ADDENDUM #4
SCCOE RIDDER PARK BACKUP GENERATOR

Bid # B 03-23-24

SANTA CLARA COUNTY OFFICE OF EDUCATION

Prepared by Architect
Artik Art and Architecture
394-A Umbarger Road
San Jose, CA 95127
(408) 224-9890

9 CHAIN LINK DOUBLE GATE 1/4" = 1'-0"

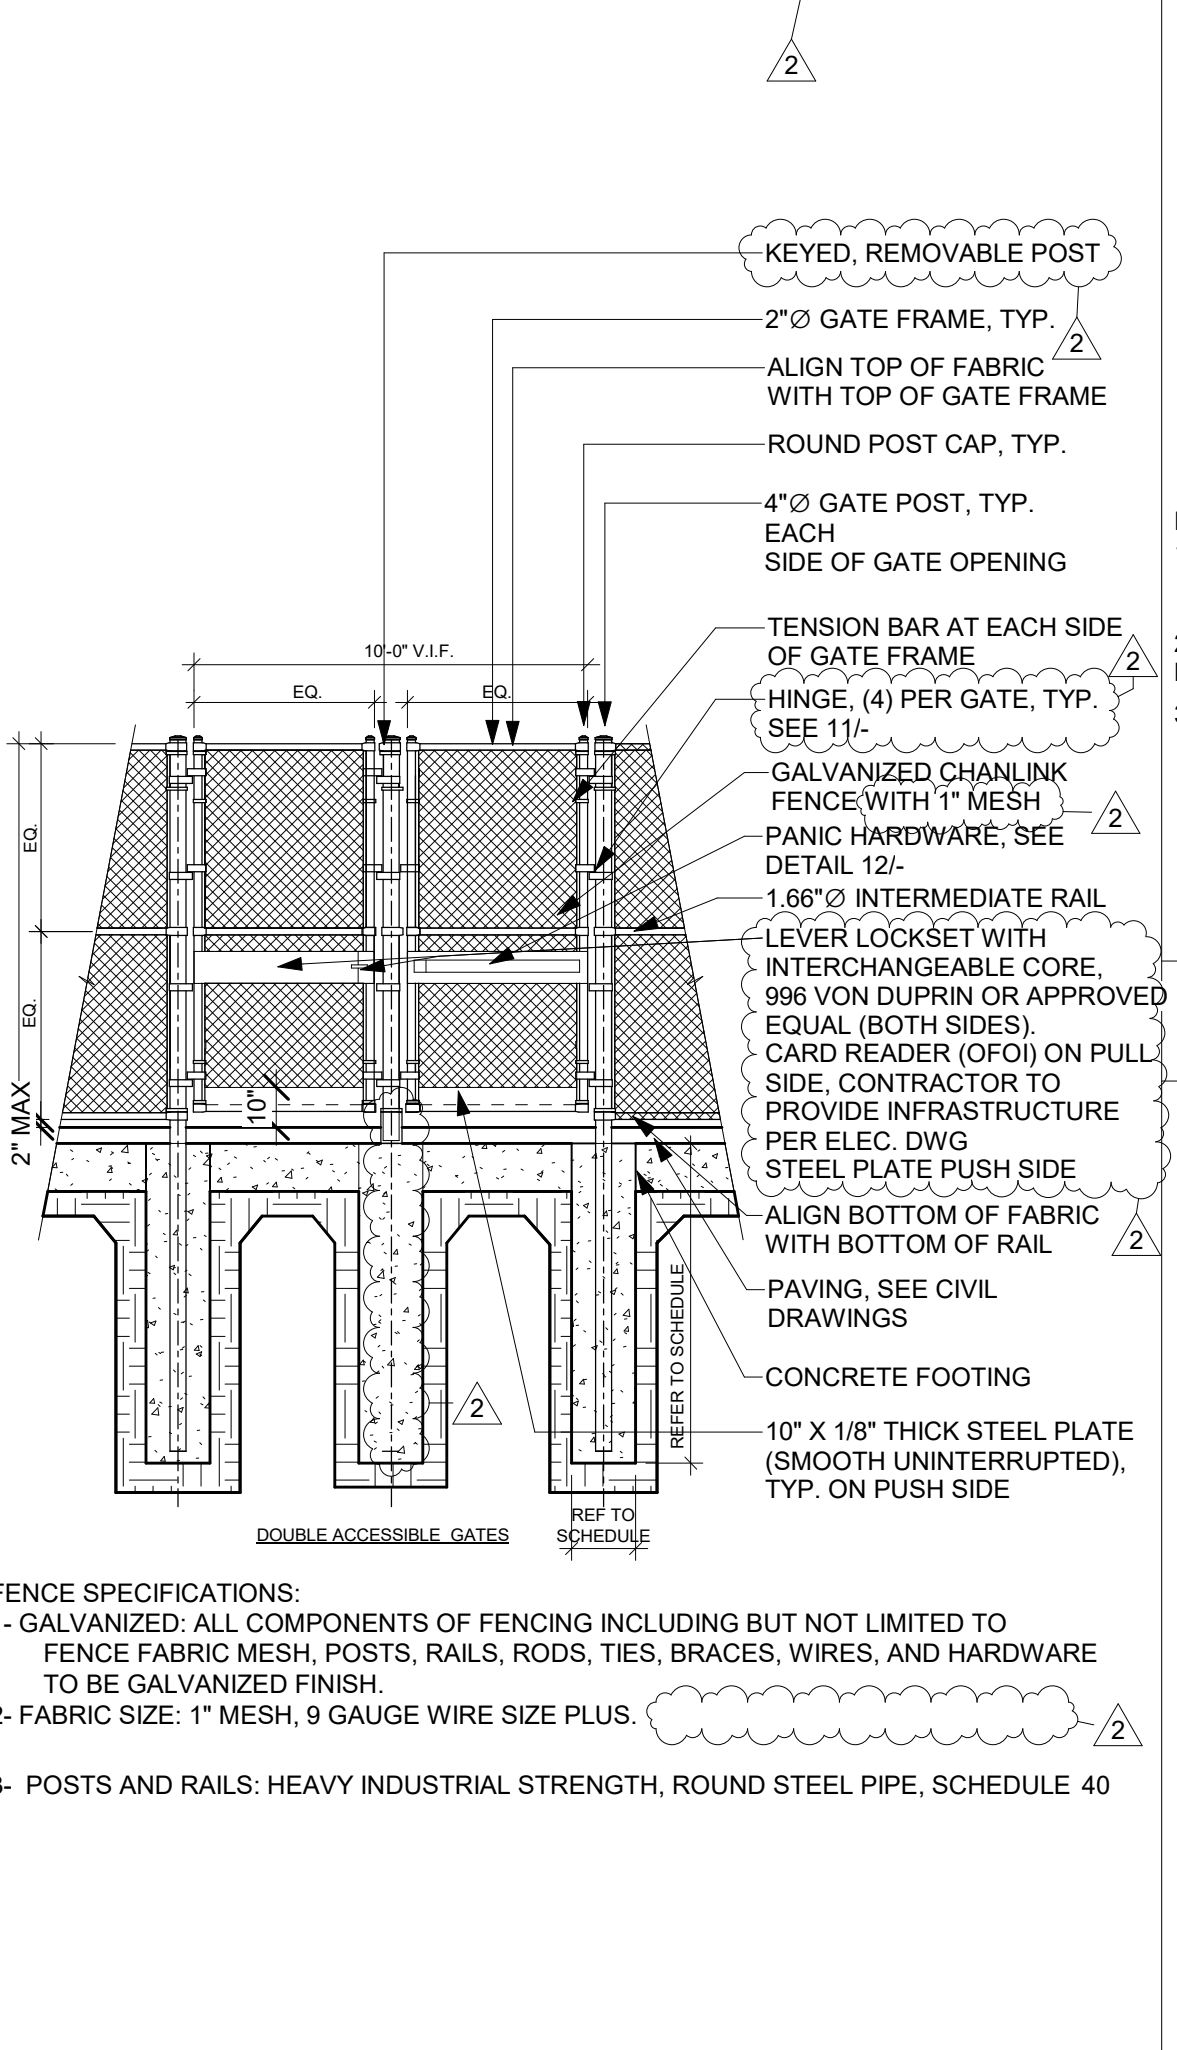
- A. Detail 4 – refer to updated notes
- B. Detail 5 – refer to updated notes
- C. Detail 6 – refer to updated notes
- D. Detail 9 – refer to updated notes
- E. Added Detail 11 for self-closing hinge
- F. Added Detail 15 for the base plate
- G. Added Detail 16 for existing gate modifications

7. Please clarify the chain link fabric size for the panic hardware gates, detail 9/A12.12 calls for 1" mesh with slats – slats are not made for 1" mesh. Are slats required at the gate – if so 2" mesh will need to be installed?

9. Detail 9/A12.12 notes “Lever, Card Reader”, is a card reader required and if so – who is to install the card reader, provide model info spec etc... also what would it connect to?

Answer: 2" mesh for the fence/gates with privacy slats, 1" mesh for gate/ fence without privacy slats. Refer to updated detail 9/A12.12

Answer: See updated detail 9/A12.12; Card reader OFOI, infrastructure by Contractor.

5 CHAIN LINK SINGLE GATE 1/4" = 1'-0"

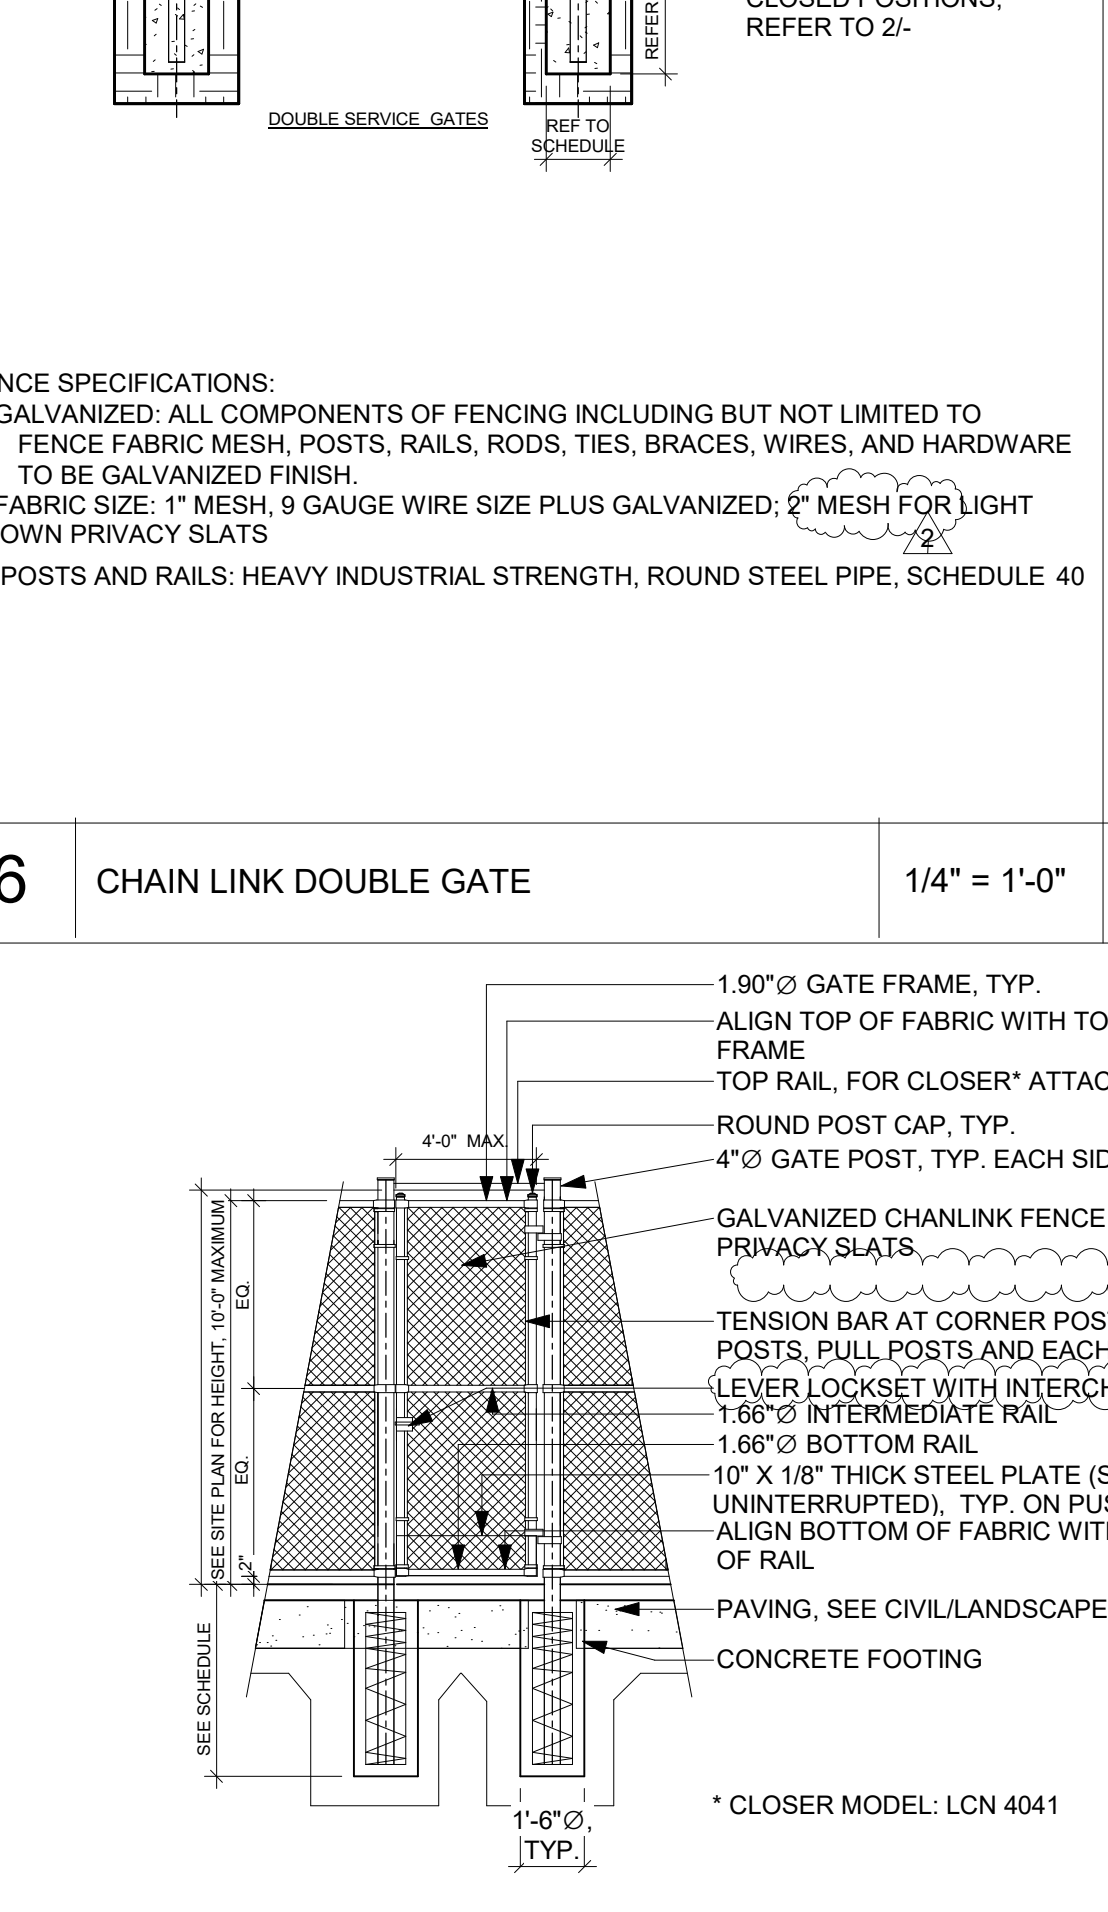
8. Please provide the locking device required for the single chain link gates detailed in 5/A12.12 call for Gate operator & Locking mechanism – that is not enough information – please clarify – is this a padlock-able latch or a lever lockset?

Answer: Lever lockset with cylinder interchangeable core, refer to updated details.

4 CHAIN LINK FENCE 1/4" = 1'-0"

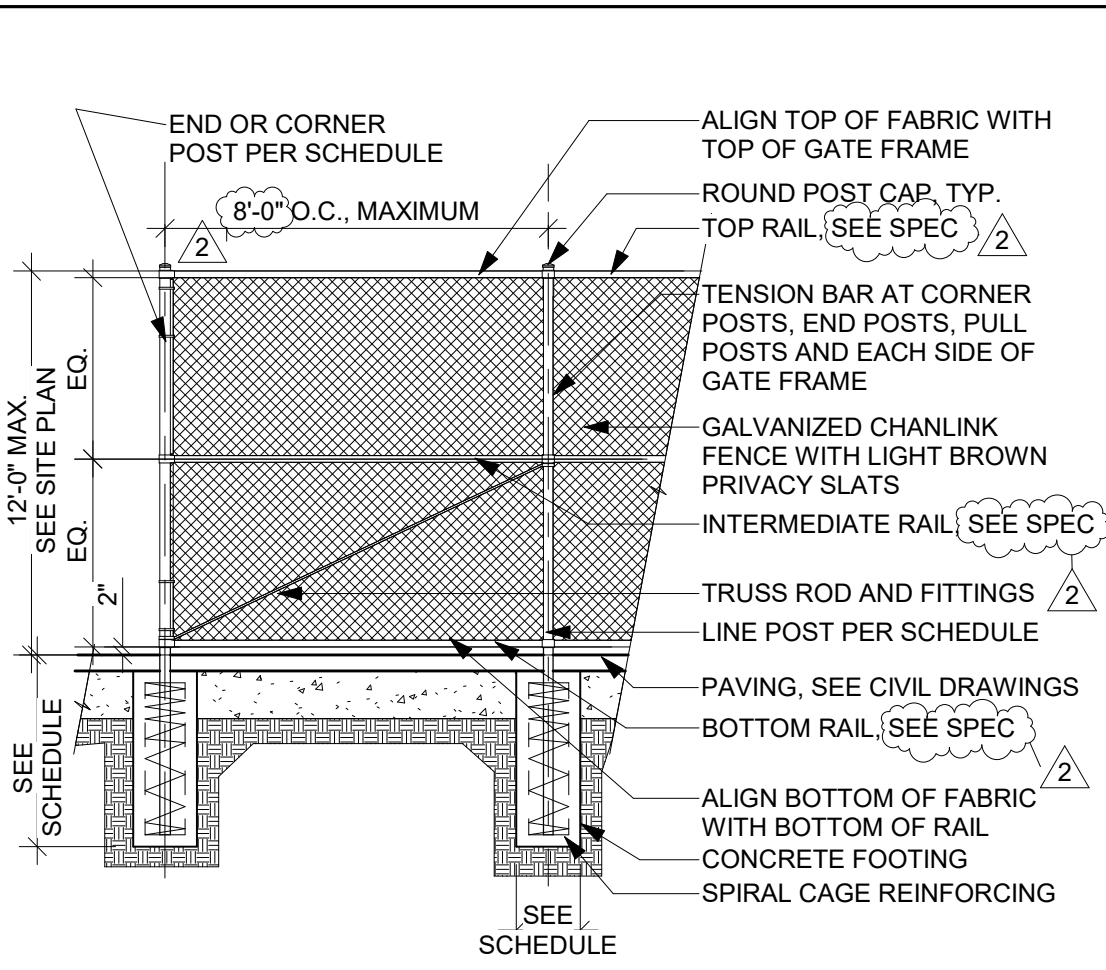
5. Please clarify the post spacing 8'-0" o.c. per the spec or 10'-0" o.c. per the detail 4/A12.12

6. Please clarify the top-mid and bottom rail size 1.66" od Per the spec (typical standard for CL fence) or per the note in Detail 4/A12.12 which call for rails to be the same size as the posts (4" OD – which is massize and not typical for a CL fence design)?

Answer: Detail 4/A12.12 refers to maximum spacing. Refer to structural drawings for post spacing and specifications.

Answer: Refer to spec and updated detail.
